**ADDENDUM NO. 2
10/10/24**

SPECIFICATION NO. 24-11649-C

CITY OF BERKELEY

OHLONE PARK RESTROOM AND LIGHTING

ELECTRICAL PLAN

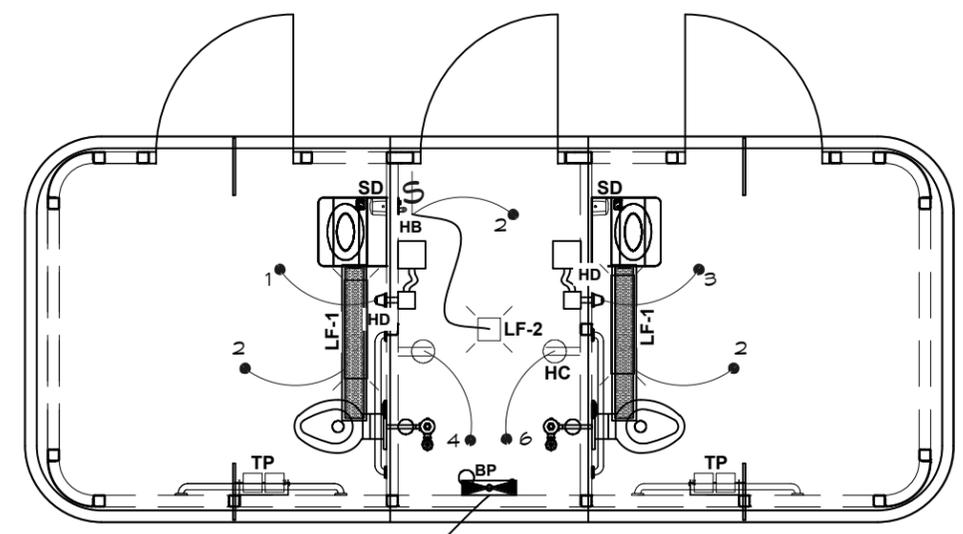
1. Replace the following sheets with updated sheets:
 - a. Romtec Pre-fab restroom sheets:
 - i. G0 – added clarification on general note
 - ii. G1 – revised special inspection note
 - iii. S7.2 – revised location of callouts so they didn't block other information
 - iv. E1 – clarified scope of work for underground electrical
 - v. E2 – clarified scope of work of service utility equipment in detail 1

UNDERGROUND ELECTRICAL SERVICE VERIFY REQUIREMENTS FOR TYING INTO SERVICE UTILITY EQUIPMENT
